A C Z INC.

Re: 10/10/84 Site Visit to North American Equities
Blazon No. 1 Mine

will place a trash rack at the inlet to prevent future blockage. I have enclosed culvert sizing calculations for both segments of the new culvert (Designated Culvert F') as well as the original culvert for your reference. Also enclosed is Map 9, Blazon No. 1 Mine - Surface Facilities, which shows the location of the new culvert and a detail sketch illustrating trash rack construction.

NORTH AMERICAN EQUITIES
TYPICAL TRASHRACK STRUCTURE
FOR SMALL DIAMETER CULVERTS
FIGURE II

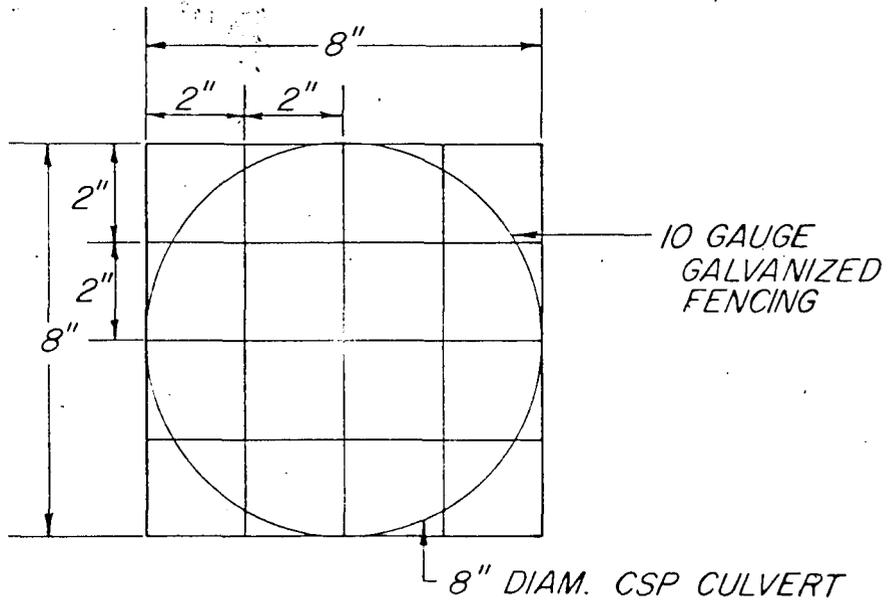
Due to the amount of material covering the existing culvert (Culvert F), it appears impractical to excavate and either repair or replace this culvert. Consequently, North American Equities (NAE) plans to install a new culvert with its inlet at approximately the same location as the existing culvert. The new culvert will be placed in a shallow trench running from the inlet through the narrow portion of the mine development waste pile to a daylight point immediately west of the waste pile. A second culvert section, joined to the first by a pipe elbow, will carry the flow down the hillslope where it will discharge to Ditch B. NAE will place suitable riprap material at both the inlet and discharge of the new culvert to minimize erosion and
